HUMBOLDT STATE UNIVERSITY

SUBJECT: IFB #PW20-1, Emergency Power Generators

Addendum #1

1.02 PROJECT: 1901734 HSU CRITICAL ELECTRICAL GENERATION

3.01 DRAWING E-1.1 - FORBES FIRST FLOOR PLAN:

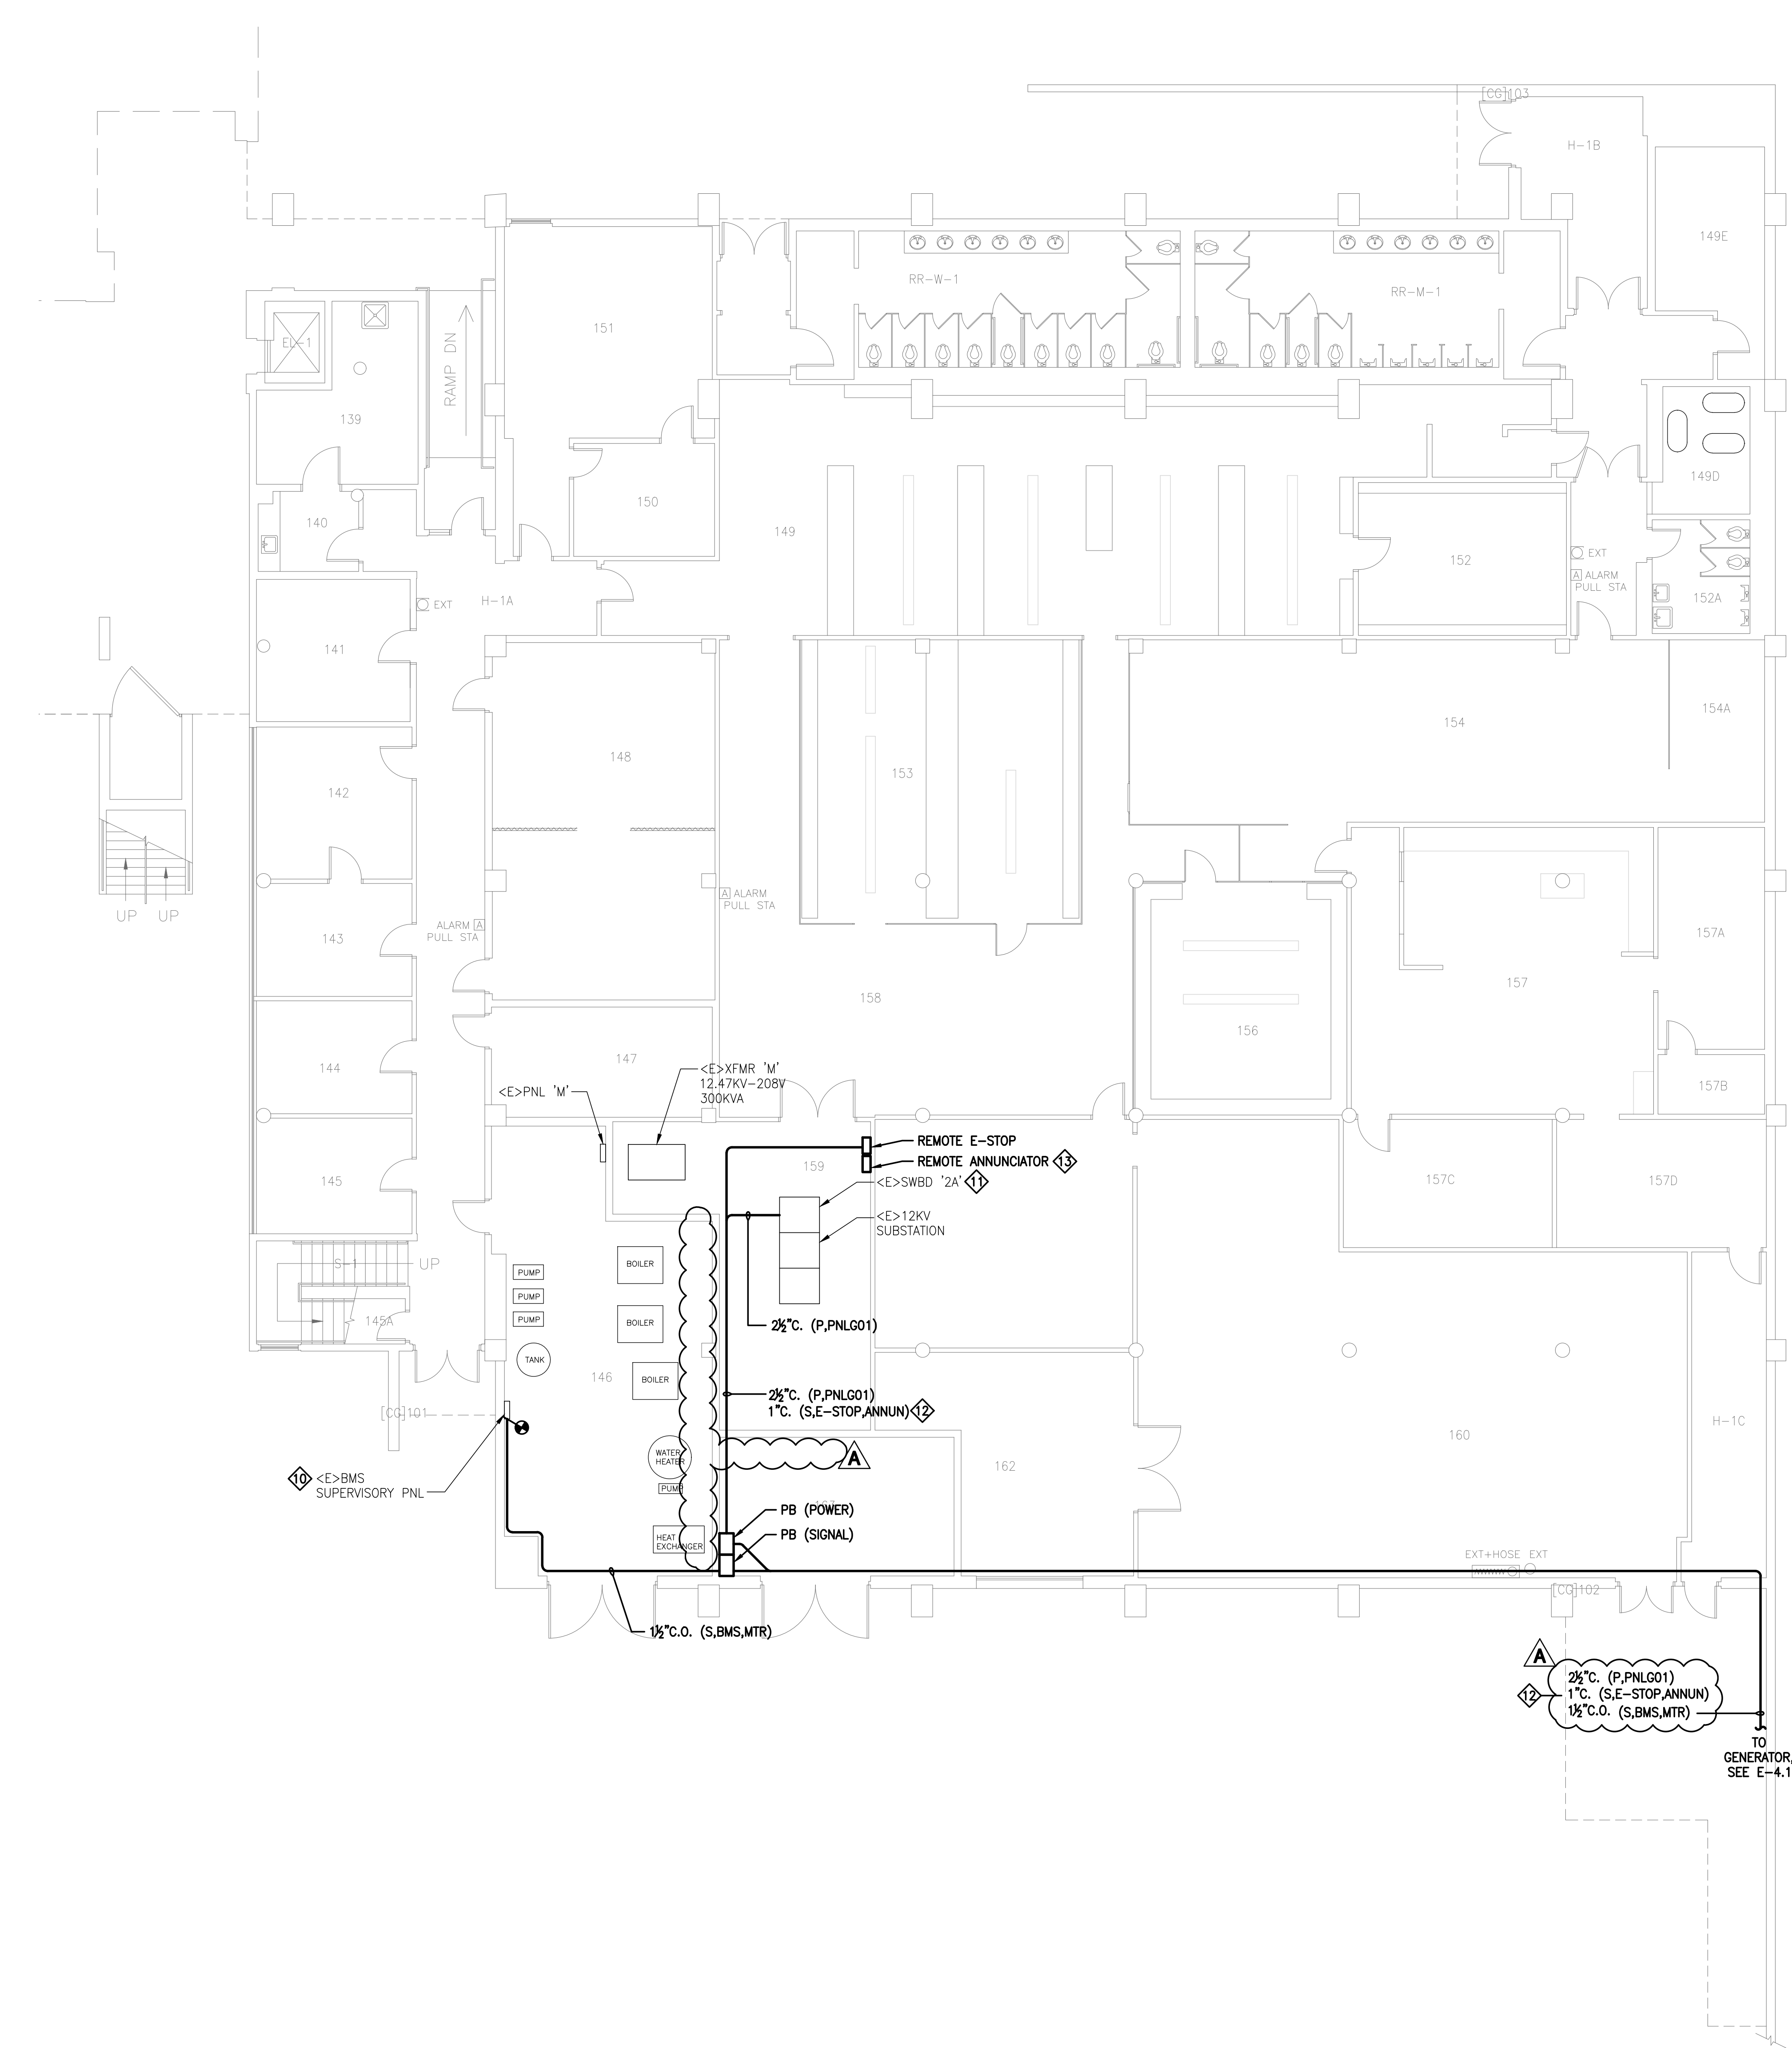
- A. Replace Sheet E-1.1 in its entirety, reflecting the following modifications:
1. Deleted feeder for circulation pump.

3.02 DRAWING E-4.1 - FORBES GYMNASIUM COGEN UNIT FLOOR PLAN:

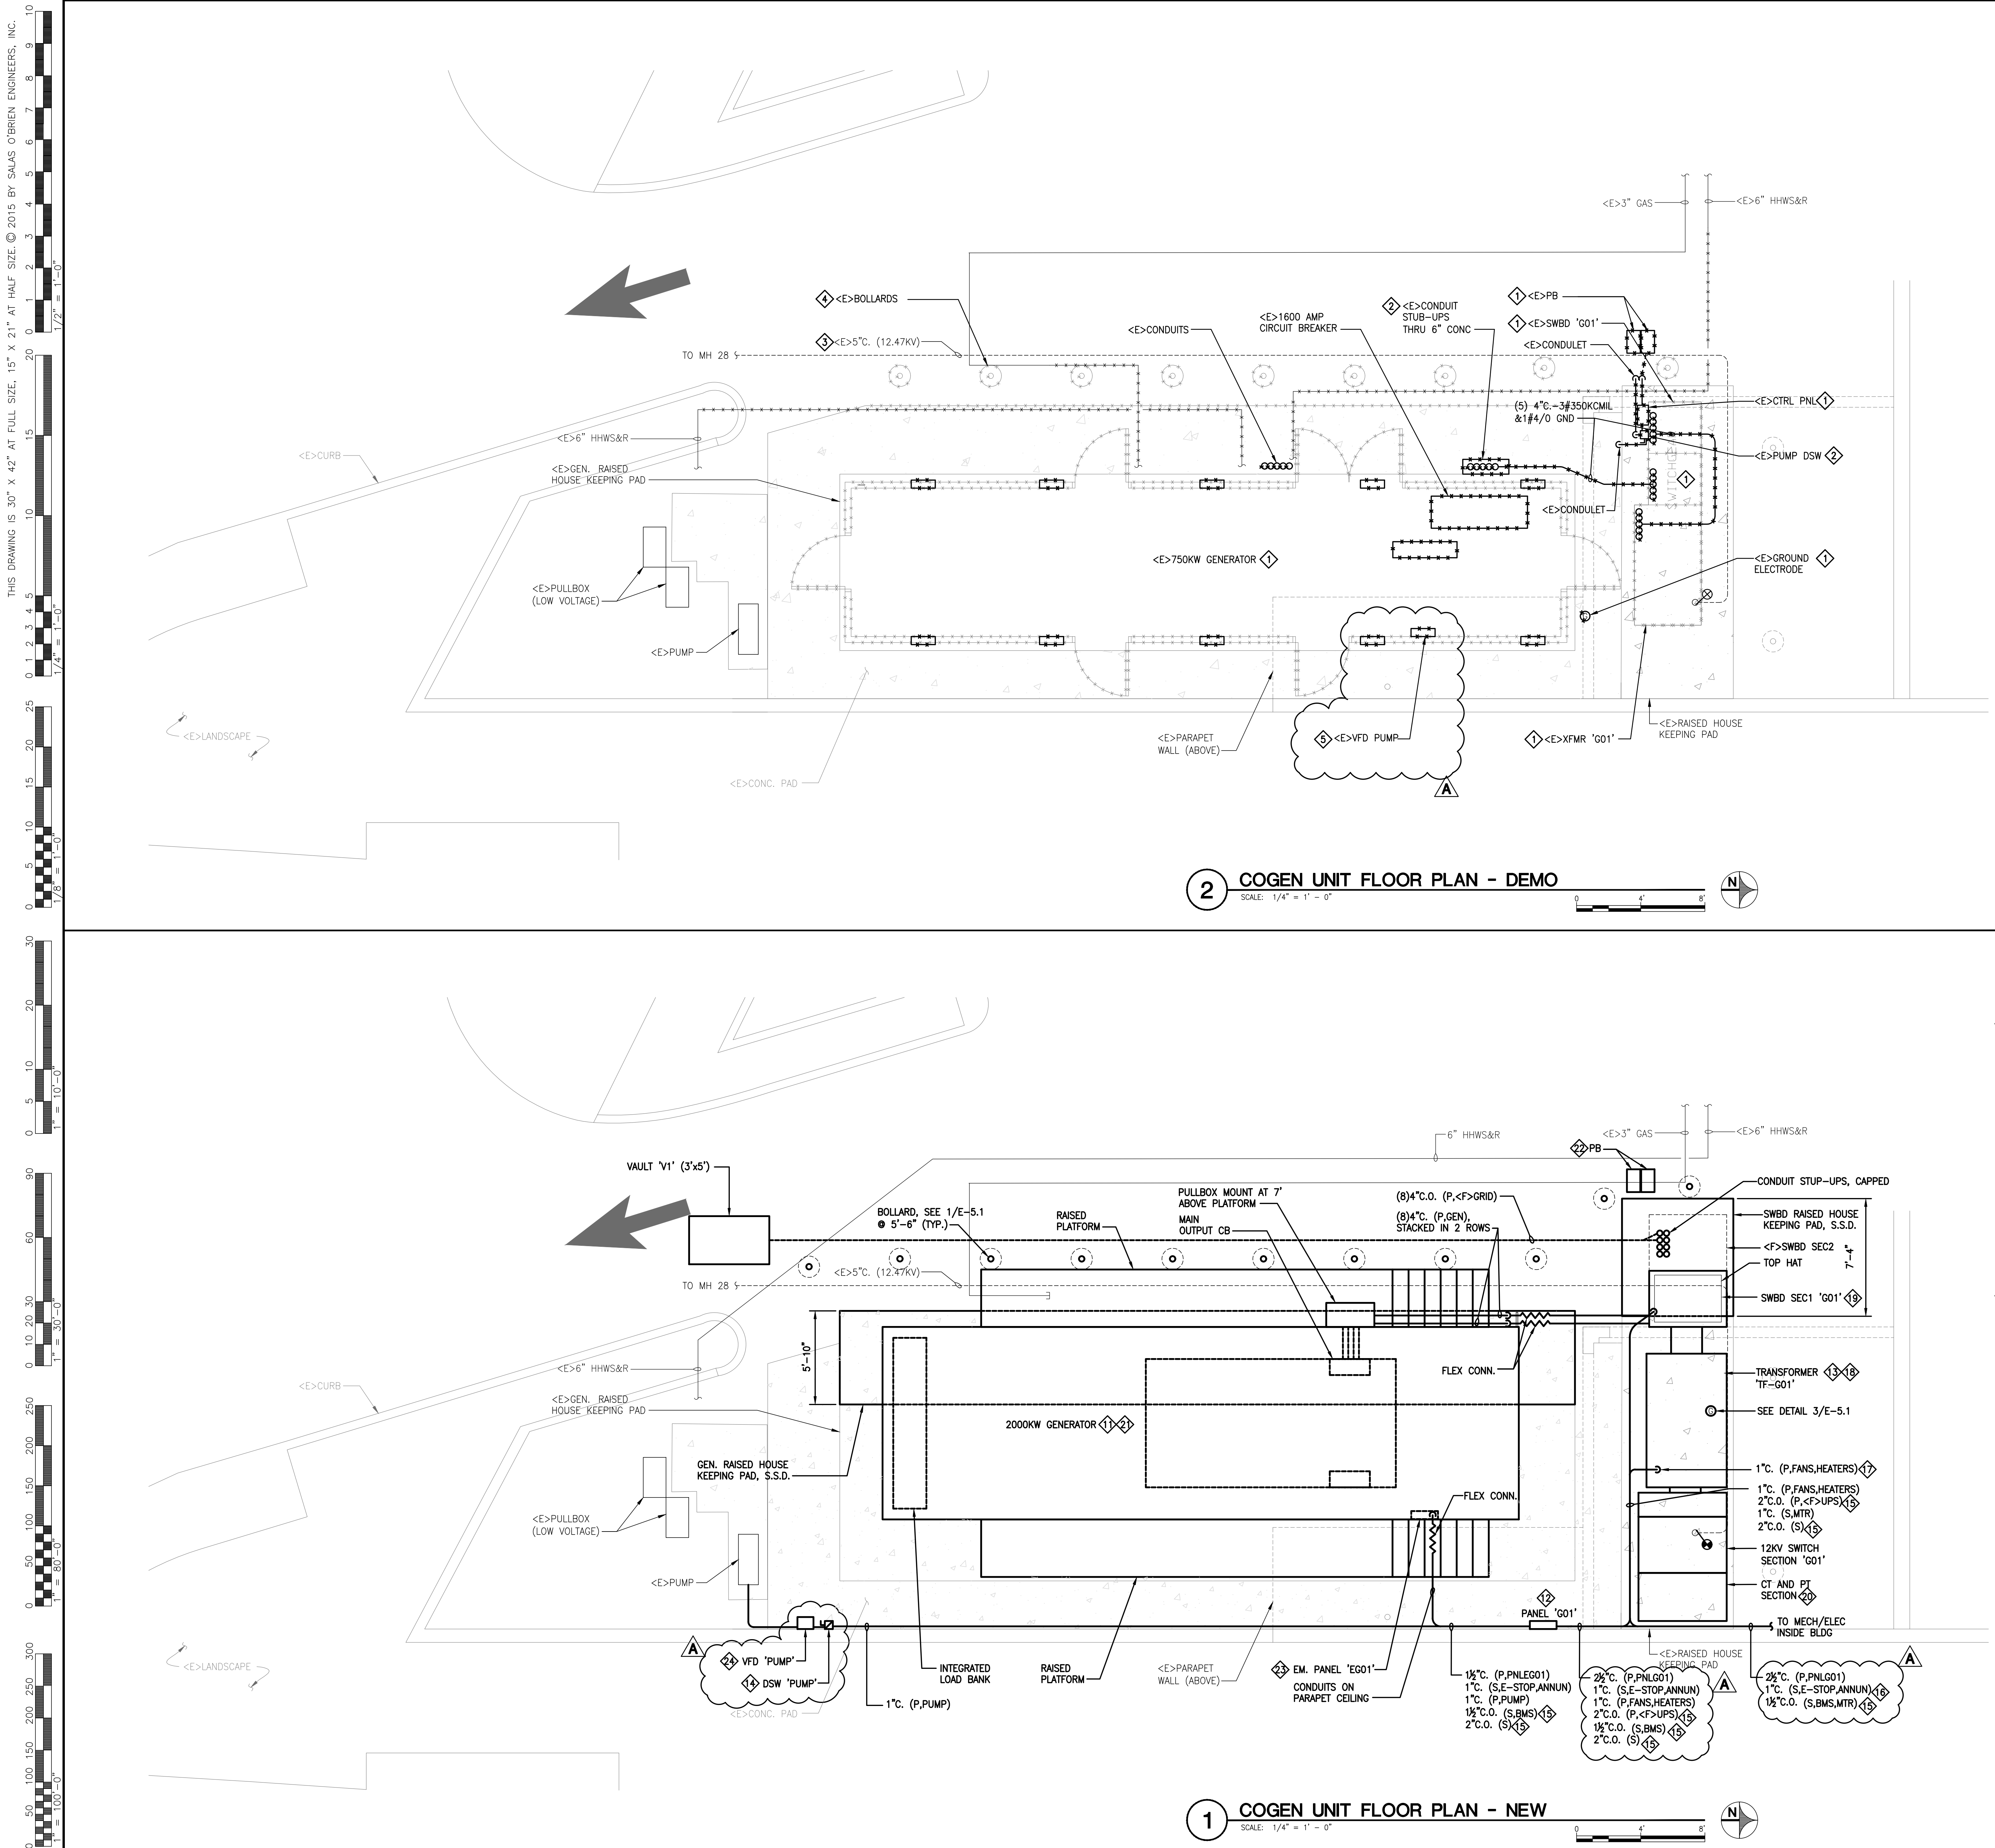
- A. Replace Sheet E-4.1 in its entirety, reflecting the following modifications:
1. Refeed circulation pump from Panel G01.

- HEAVY DUTY FUSED DISCONNECT SWITCH. SWITCH SIZE SHALL BE 60AF/60AS/3P RATING. ROUTE 1" C. - (3)#4 + #8 GND. FROM PANEL G01 VIA NEW VFD. PROVIDE 100A/3P CIRCUIT BREAKER.

3.03 DRAWING E-6.1 - FEEDER AND EQUIPMENT SCHEDULES, AND SIGNAL LINE DIAGRAM:

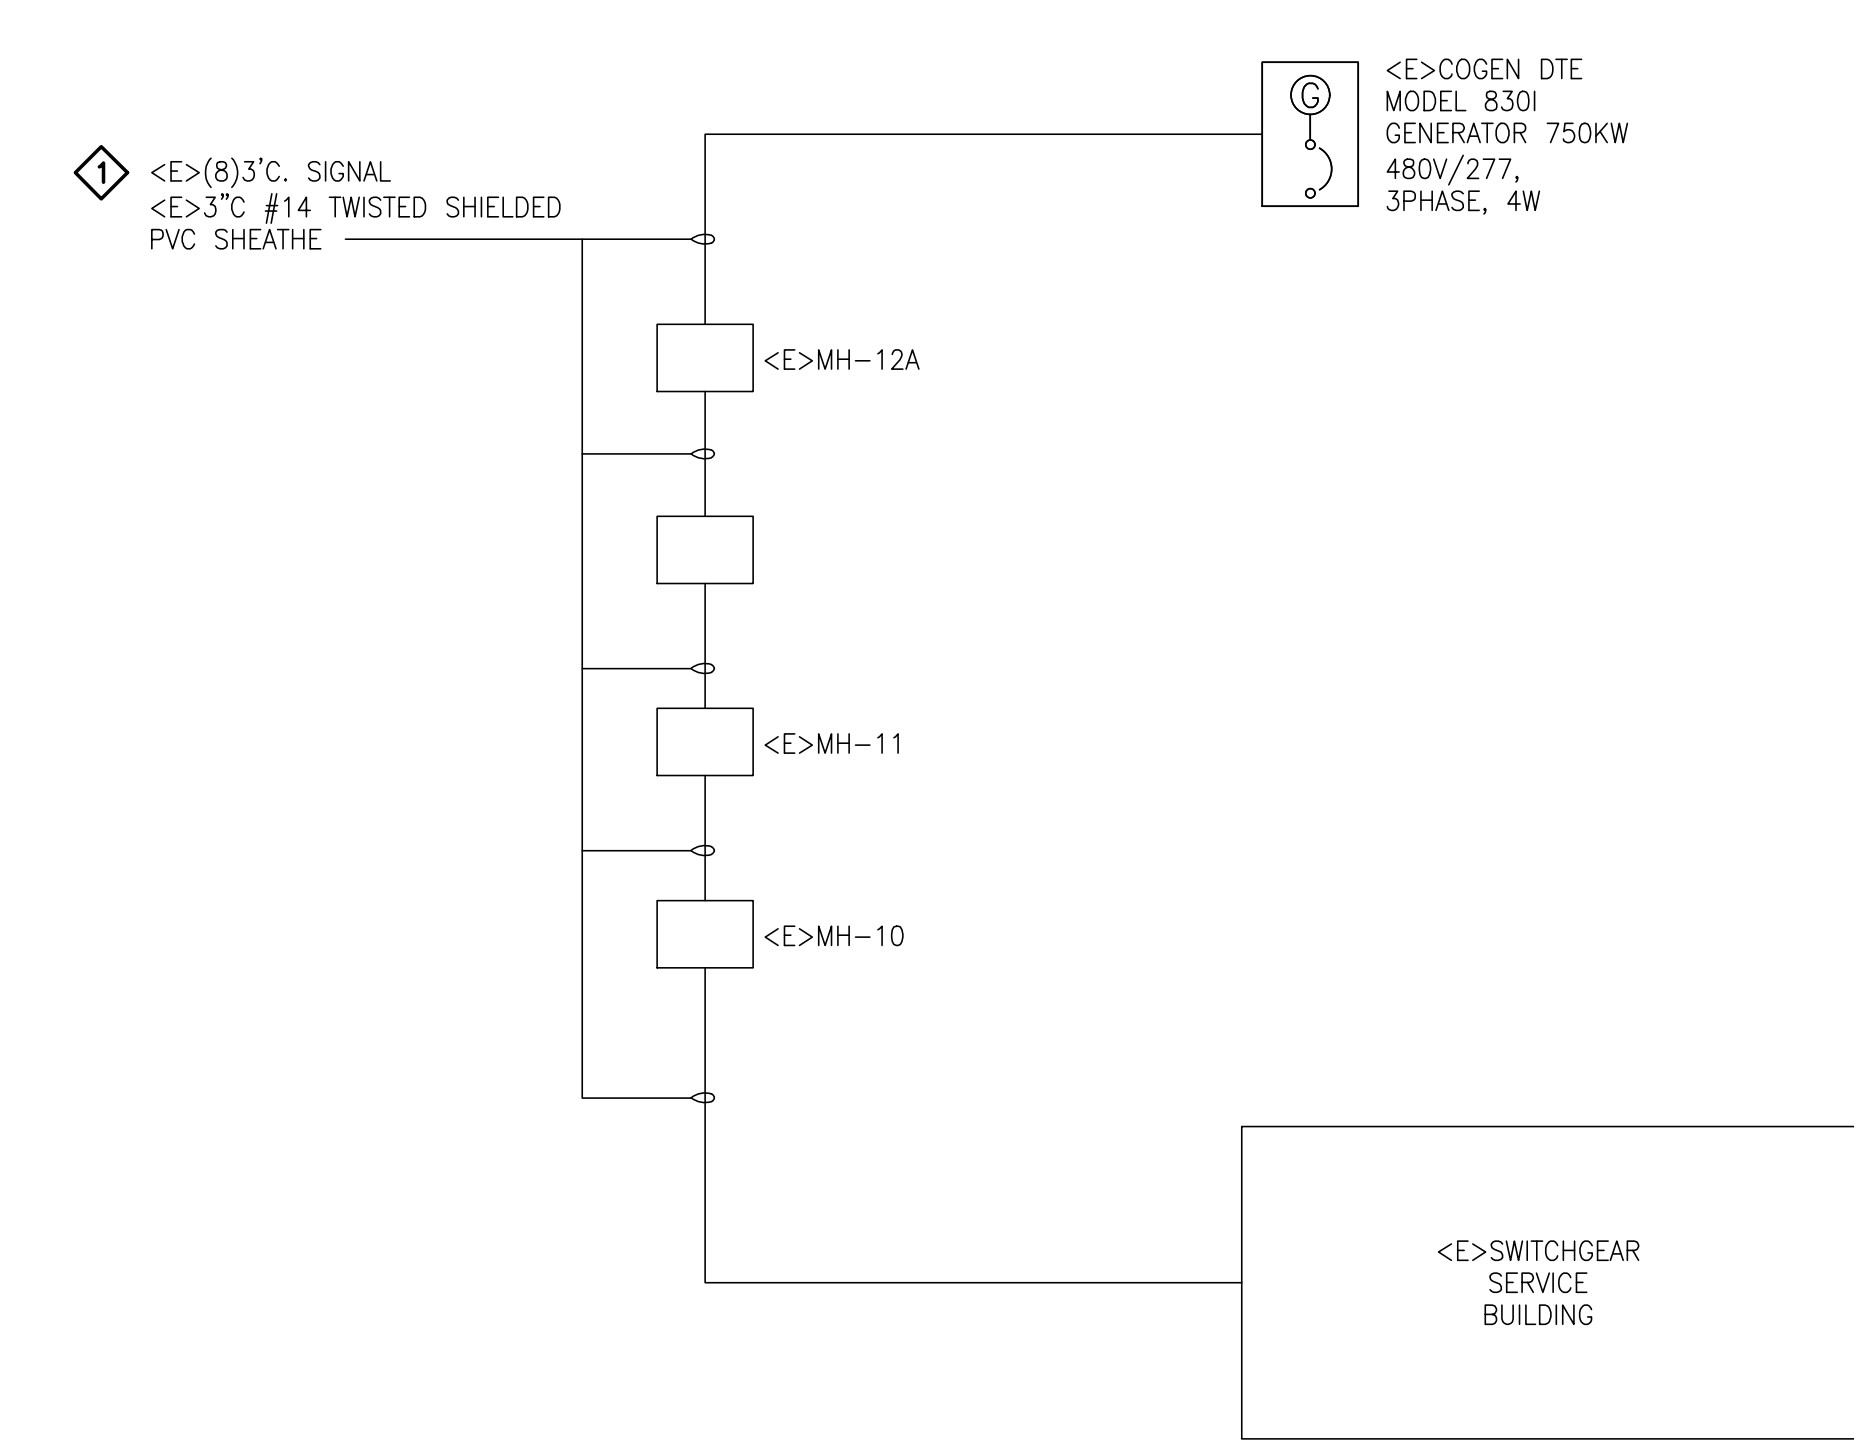
- A. Add Sheet E-6.1, reflecting the following changes:
1. New Panel Schedule.
